Delegated Report

Approval of Details Application

Planning Application No: 20250491

Description: Application for approval of conditions 22 attached to planning permission reference number 20200343 relating to a strategy for the allocation and safeguarding of parking spaces for the occupiers of the development.

Level 00:

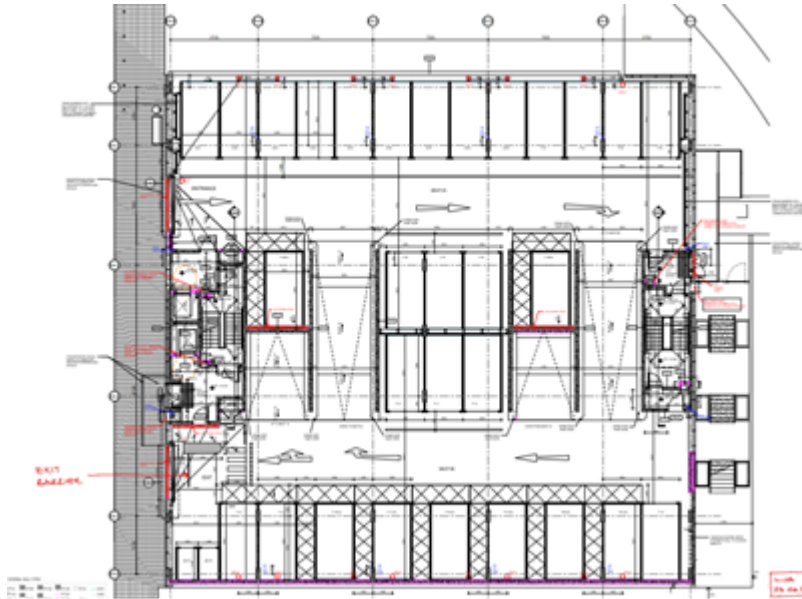
- The 'Supplementary Information' document refers to barrier controlled areas, but no barriers are shown on the plans. The plans should be updated to show these.

- Plan 04051 (Level 00 GA Plan) shows a roller shutter located at the car park entrance. Please confirm if this is controlled by ANPR to allow residents access when the public car park is closed.

The details include provision and confirmation of barriers, ANPR system and also clearly shows the allocation of parking Bank Street, New Swan Yard (for medical use only), disabled spaces and EV charging points.

General Layout

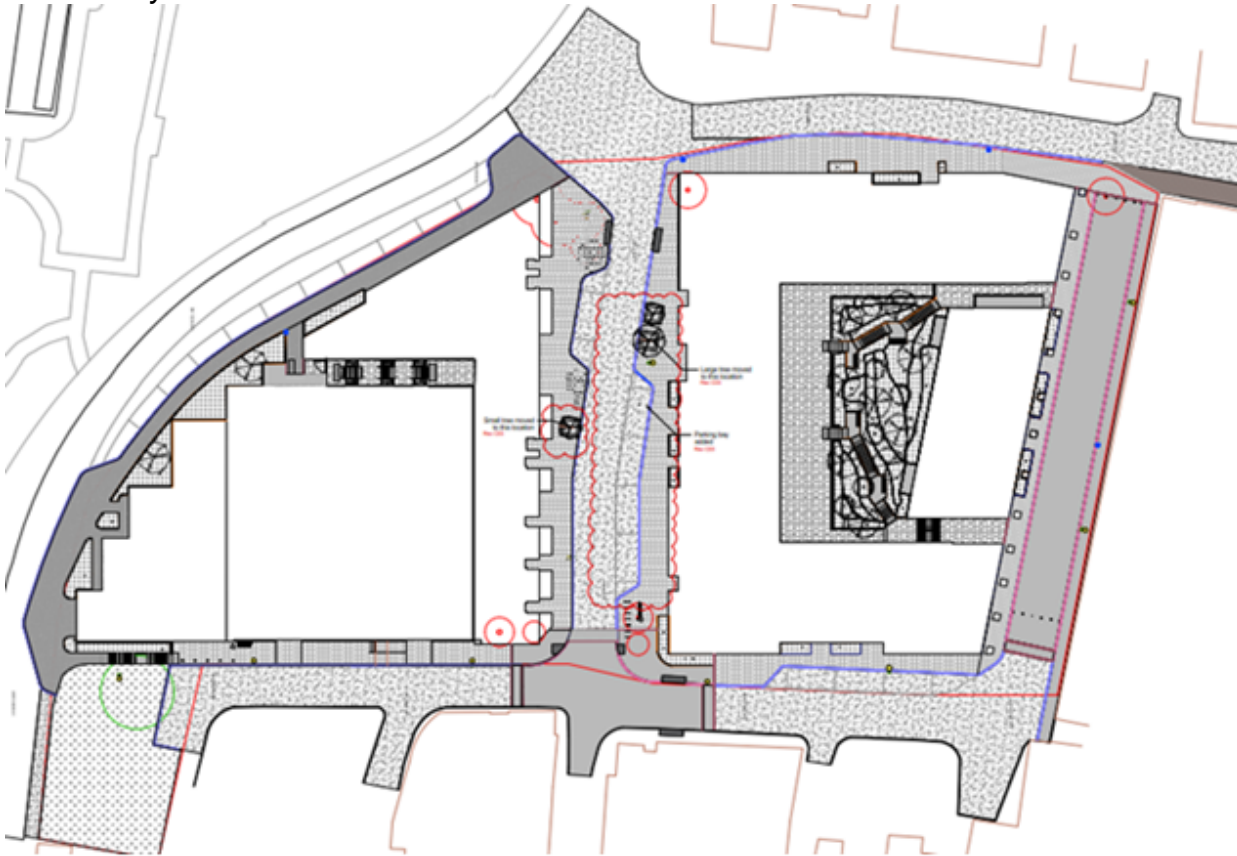
- Based on the Kent Highways response to the original application (dated 5th June 2020) it is understood that a small number of parking bays are to be provided on New Swan Yard and Bank Street for short term parking. However, these are not referred to in the submission.

- The allocated spaces for the medical centre do not contain any disabled spaces, which is unusual. Are these spaces for staff or patients?
- Whilst the overall quantum remains the same, the allocation of residential vs public spaces has changed by one space. Whilst this is unlikely to affect the adopted highway, no explanation has been given.
